# Access Compliance Report

## Public Rights-of-Way

Intersection ID: 4945	Main Street: LAWNMEADOW_DR	Cross Street: REAMES_RD	Location:	NW
ADA ID: E1726A34B3C1	Ramp Type: Perp	Initial Pass/Fail: Fail	Overall Compliance: No	Severity Score: 8.75

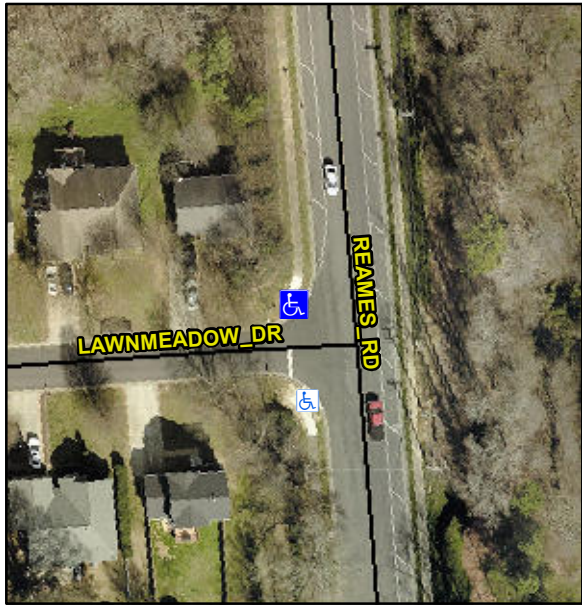
Codes/Mitigation Info/Possible Solution			Field Measurements/Component Compliance					
	Possible Solutions:		Compliance	Description	Data	Compliance	Description	Data
	Remove & Replace Entire Ramp.		N/A	Ramp Length (in)	48.5	Yes	Ramp Slope (%)	8.2
			No	Ramp Width (in)	44.5	Yes	Ramp XSlope (%)	1.8
			N/A	Flare Type LT	N/A	N/A	Flare Type RT	N/A
			N/A	Flare Slope LT (%)	N/A	N/A	Flare Slope RT (%)	N/A
			N/A	Flare Traversable LT?	N/A	N/A	Flare Traversable RT?	N/A
			N/A	Landing Length (in)	N/A	N/A	DWS Provided?	N/A
			N/A	Landing Width (in)	N/A	N/A	DWS Contrast?	N/A
			N/A	Landing Slope (%)	N/A	N/A	DWS Length (in)	N/A
			N/A	Landing X Slope (%)	N/A	N/A	DWS Full Width?	N/A
Surveyor Notes:			N/A	Landing Curb? (Y/N)	N/A	N/A	DWS Offset (in)	N/A
PROW/ADA:			N/A	Shared Landing?	N/A			
R304.5.1			N/A	Gutter Ponding?	N/A	N/A	Gutter Slope (%)	N/A
			N/A	Gutter Lip Ht (in)	N/A	N/A	Gutter X Slope (%)	N/A
			N/A	Painted X Walk1?	No	N/A	Painted X Walk2?	N/A
